Subject: Submittal of the Drilling Work Plan for RDX Groundwater Project Regional Aquifer Monitoring Well R-74, Revision 1, and Comment Response

**U.S. Department of Energy Responses to New Mexico
Environment Department Draft Comments on
“Drilling Work Plan for RDX Groundwater Regional Aquifer Monitoring Well R-74,”
Dated April 2022**

Figure 1 Proposed location for R-74

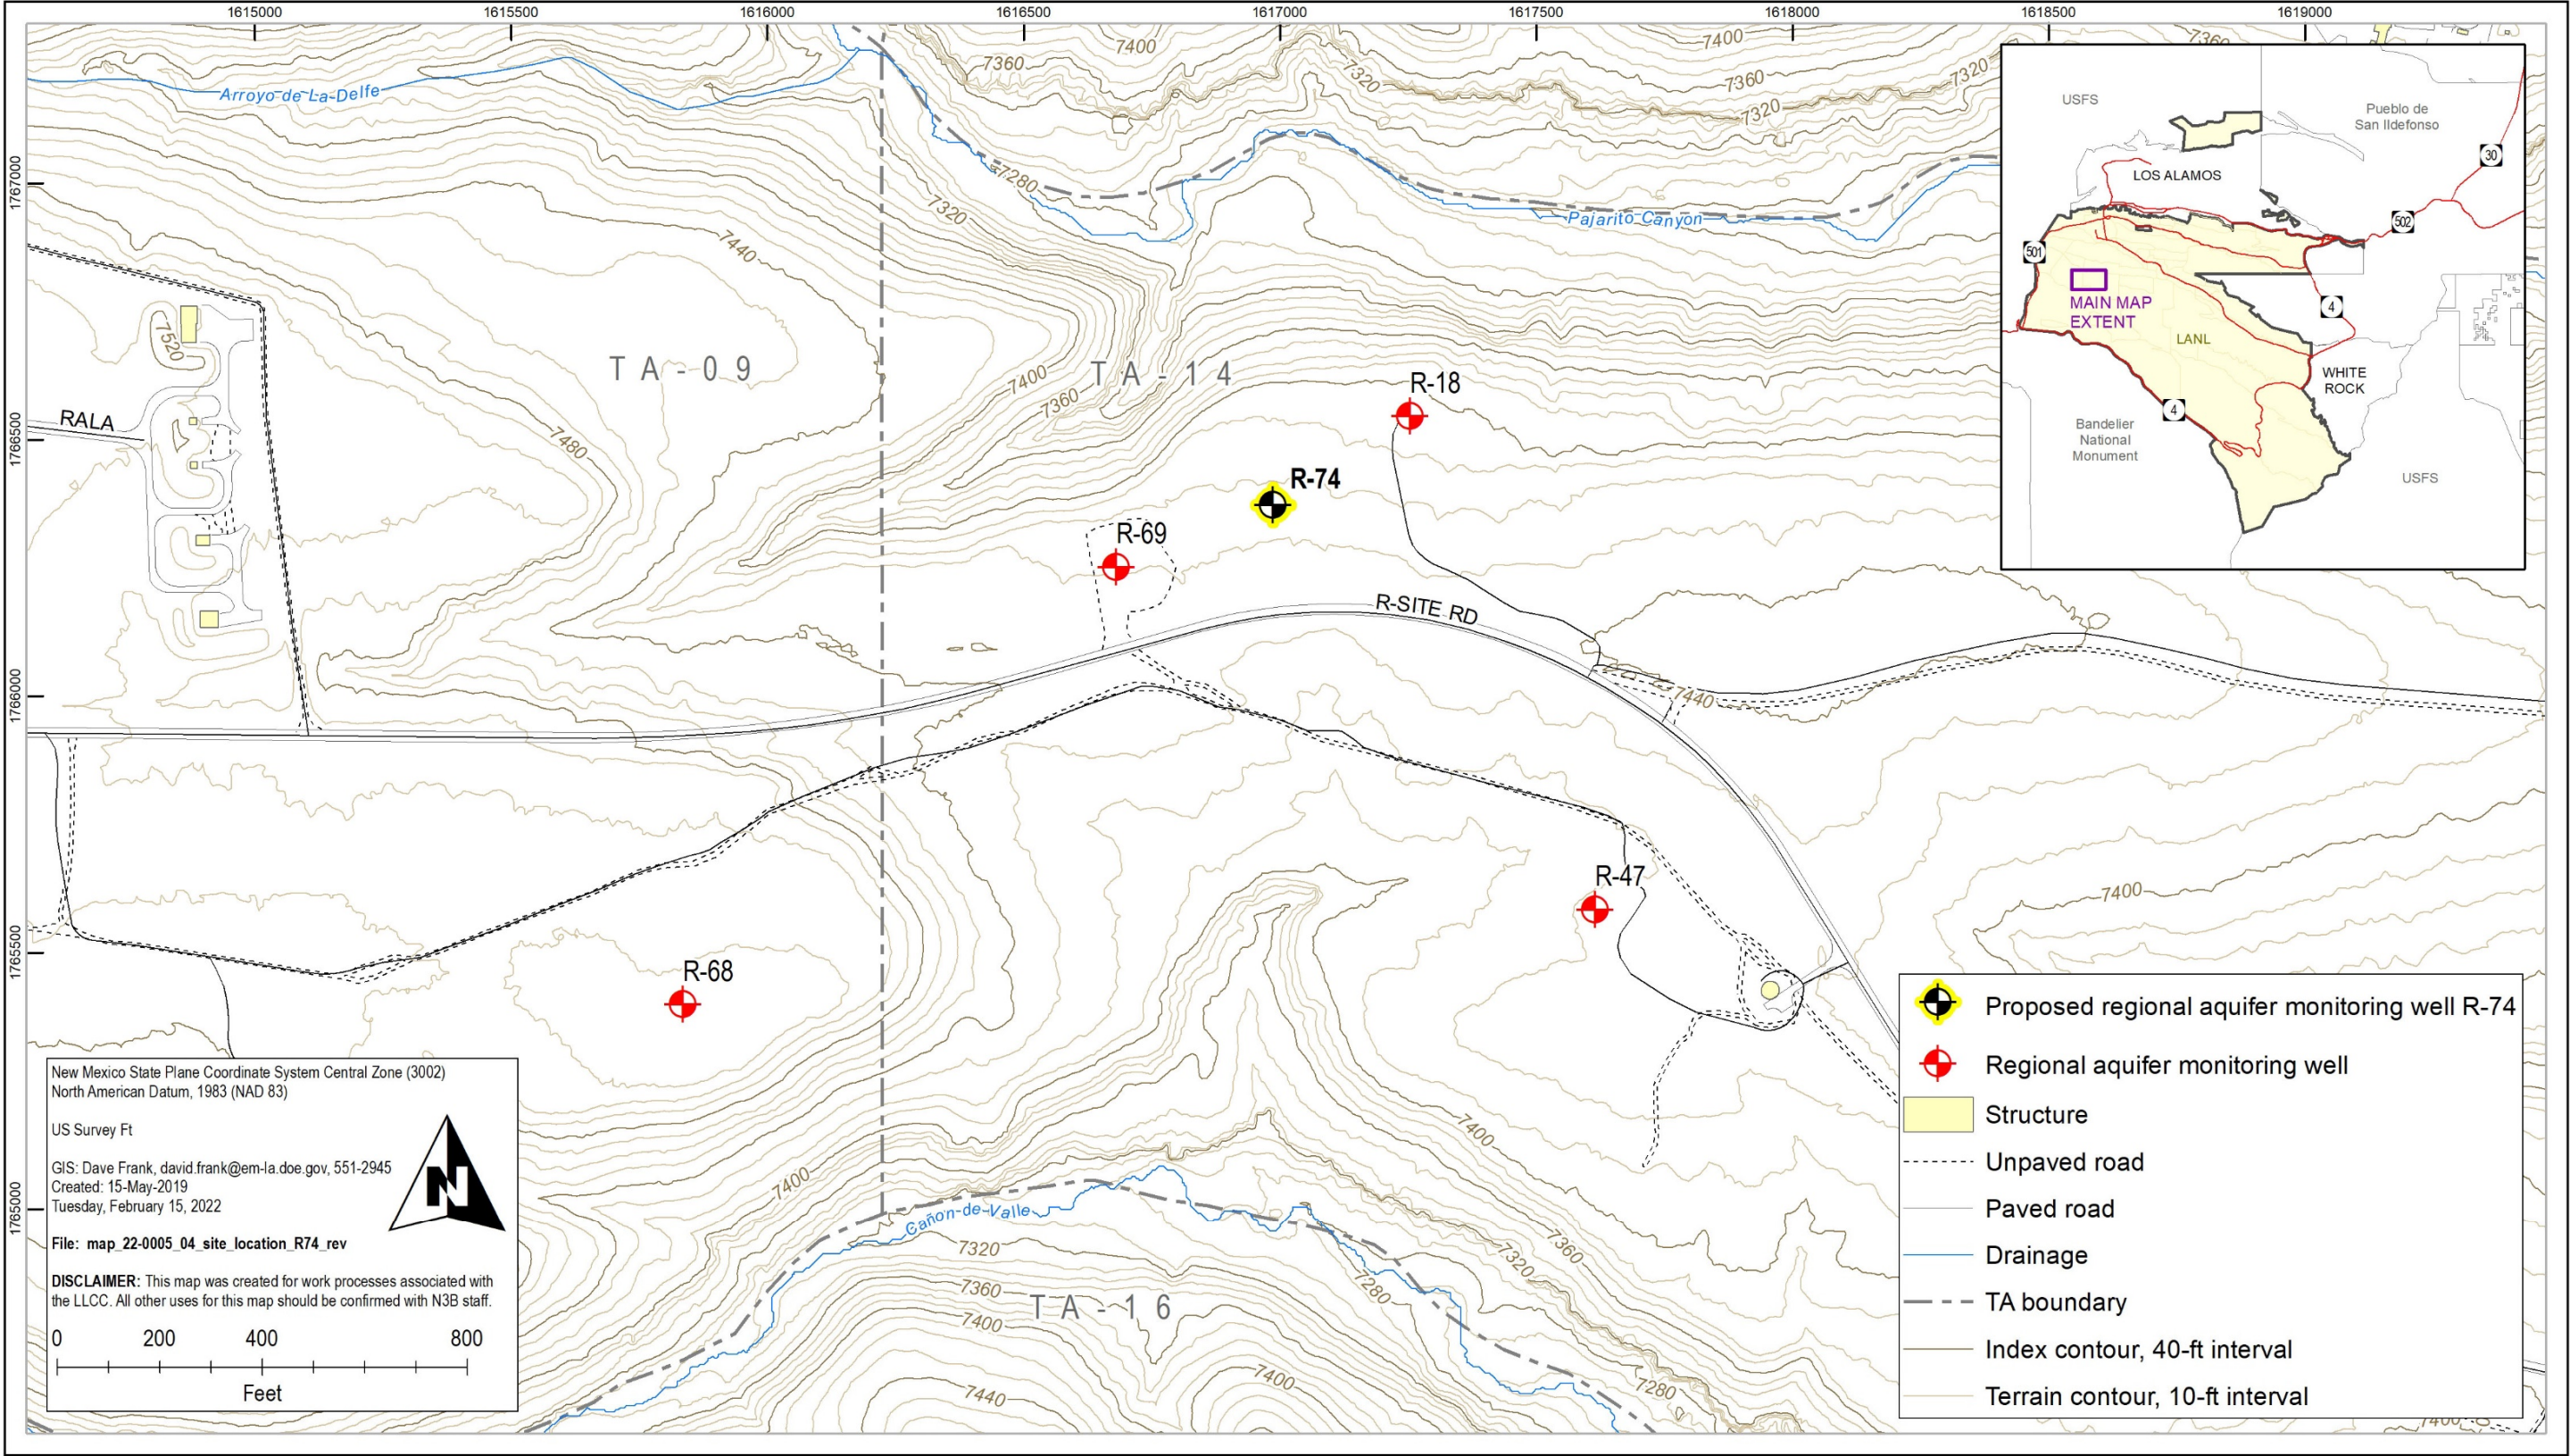
8. *Figure 1, Proposed location for R-74, Page 5.*

NMED Comment: *NMED notes that the projected RDX concentration at downgradient monitoring well R-18 will exceed the screening limit either before or during 2026. An exceedance at R-18 will require a new monitoring well to be installed further downgradient and north of R-18 across Pajarito Canyon on Two Mile Mesa to delineate the plume edge in the direction of groundwater flow. In addition, this monitoring well may also potentially serve as a sentinel well between the RDX plume flow path and the downgradient production wells. Scheduling for this well should be part of the annual planning process for proposed work for updating Appendix B of the CO. Conversely, placement of R-74 to this downgradient location may also be considered. This may be discussed during the April technical team meeting.*

8. No change to the R-74 drilling work plan is required for this comment.

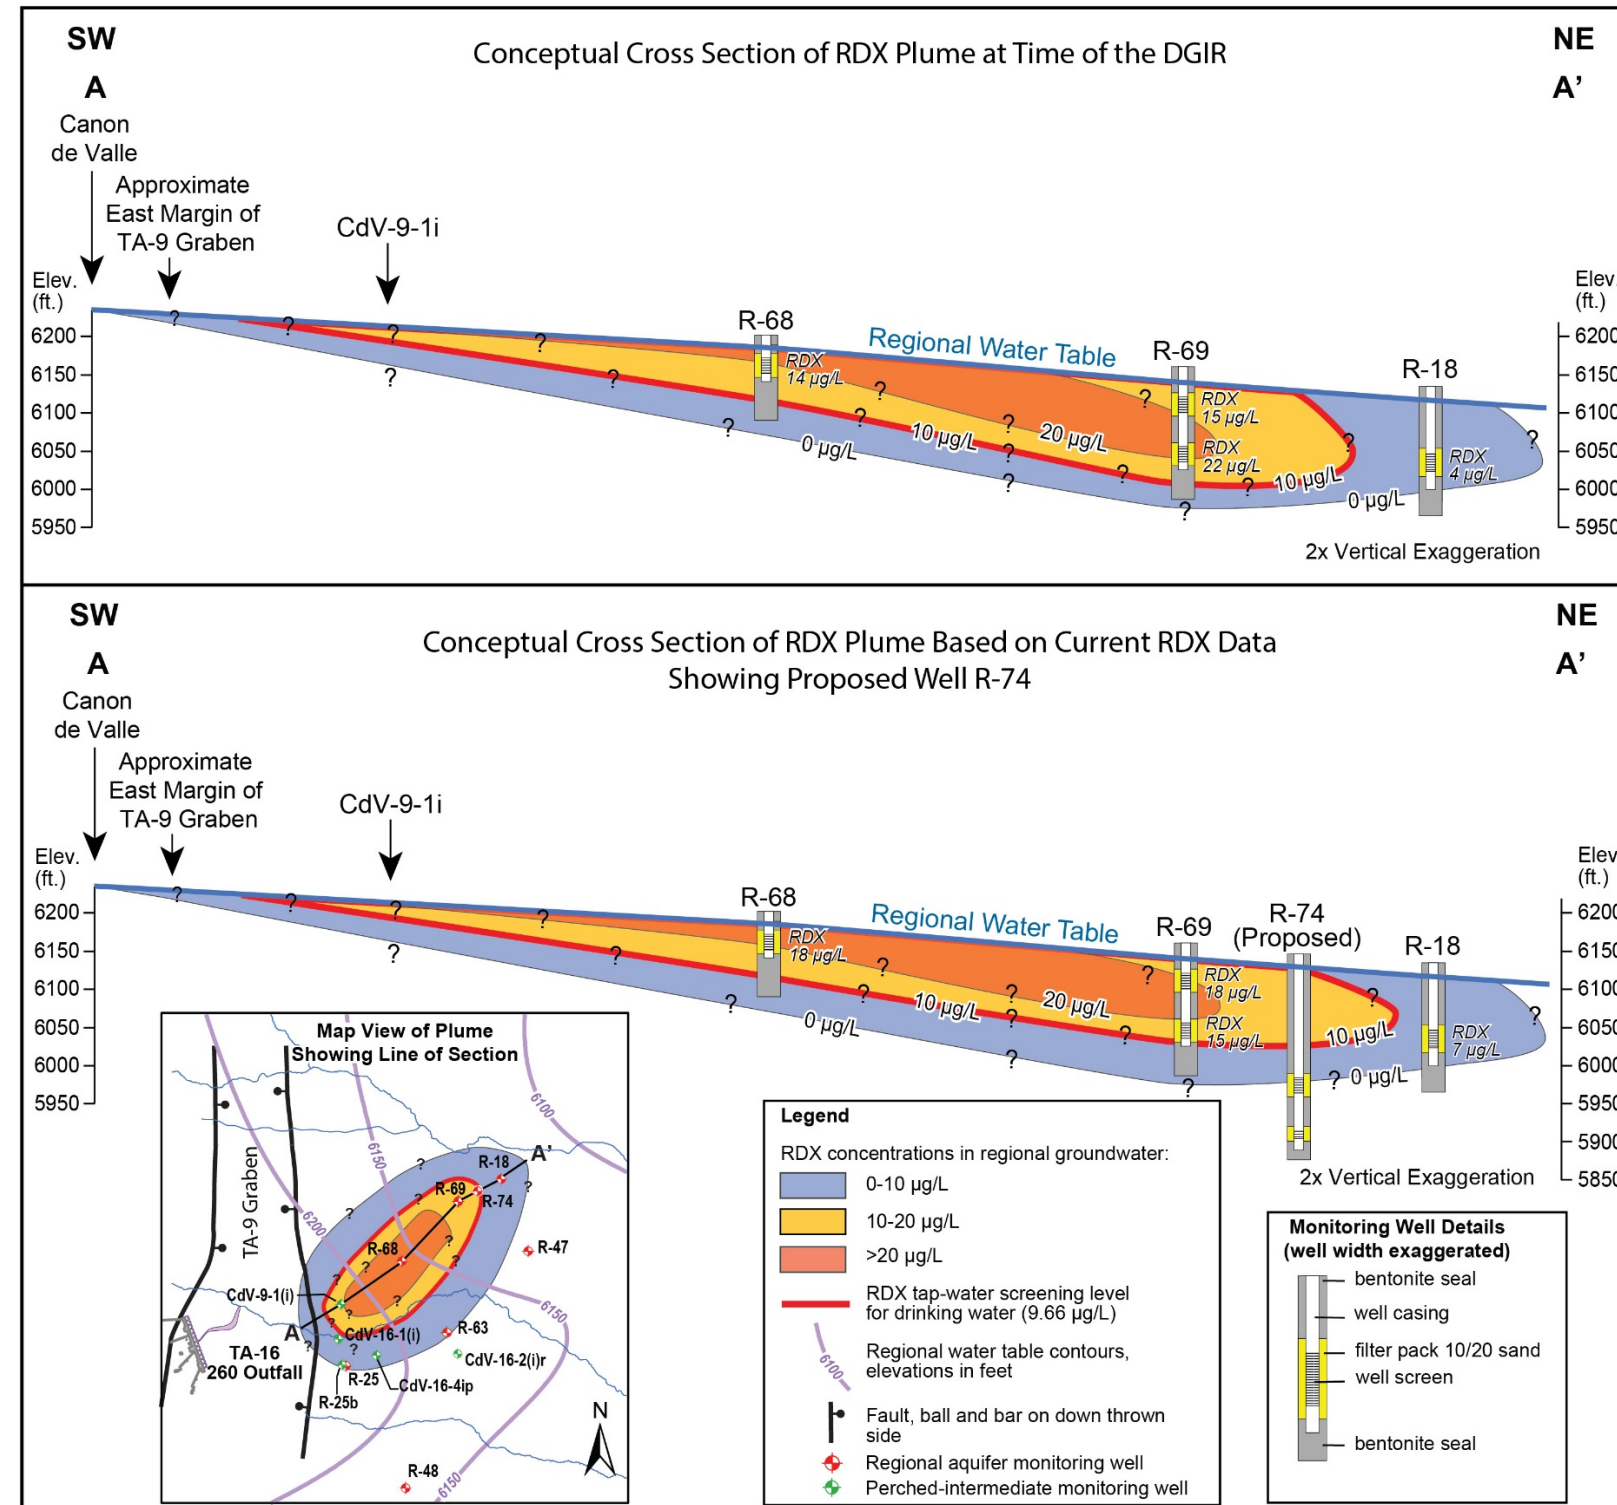
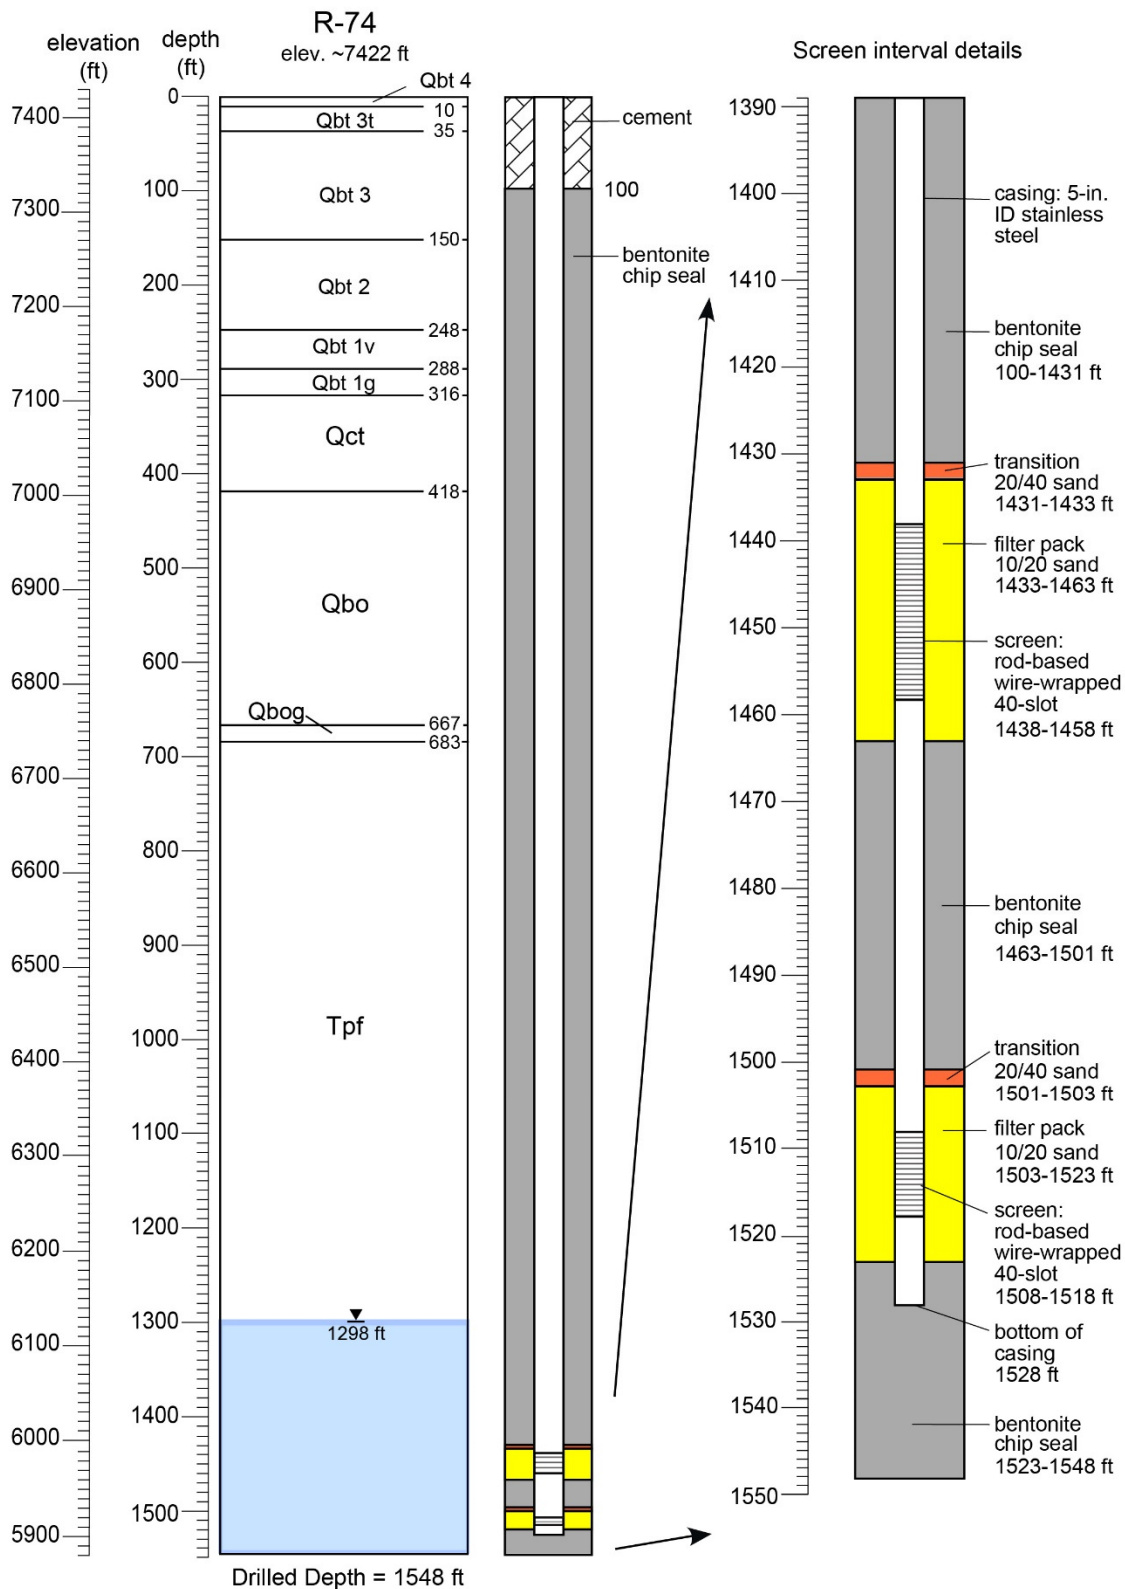
NMED Comment: In the revision, correct the length and setting below the water table of the upper screen to one appropriate for a non-water table setting. The specifications DOE provided for the lower screen at R-74 appear to be more suitable for the upper screen for R-74. However, the flow path analysis and encountered hydrogeology and water quality obtained during drilling will provide additional information for proper placement of both screens (see NMED specific comments nos. 1a, 8 and 9). Also, delete the suggested net separation distance between the well screens from the revision. Refer to NMED specific comment no. 1a to revise these statements.

9. **Figure 2, ...cross-section shows the approximated present-day vertical distribution of RDX in those same wells and also the proposed location and well-screen positions for R-74, Page 6.**

NMED Comment: The vertical distribution of RDX is not known. The purpose of R-74 screen placement is to provide the vertical distribution of the RDX near the plume center. The vertical spacing of the two well screens in proposed monitoring well R-74 should reflect deeper groundwater flow pathways from the source to the proposed R-74 drill location and consider the vertical component to groundwater movement in the area. A flow net, groundwater model, or other appropriate mathematical calculation of the three dimensional groundwater flow field that dominates the flow regime and likely affect plume migration must be considered for screen placement. See NMED specific comment nos. 1a, 1b and 1c, and revise Figure 2 in the Workplan revision accordingly.

1. a. The document has been revised to indicate that the 2 screens will be placed deeper than proposed in Revision 0.
1. b. The figures have been changed to reflect the revised screen depths.
1. c. The work plan has been revised to include additional specificity.
1. d. The revised preliminary design of the well has been included in the revised work plan.

9. The figures have been revised to reflect the new preliminary well design.
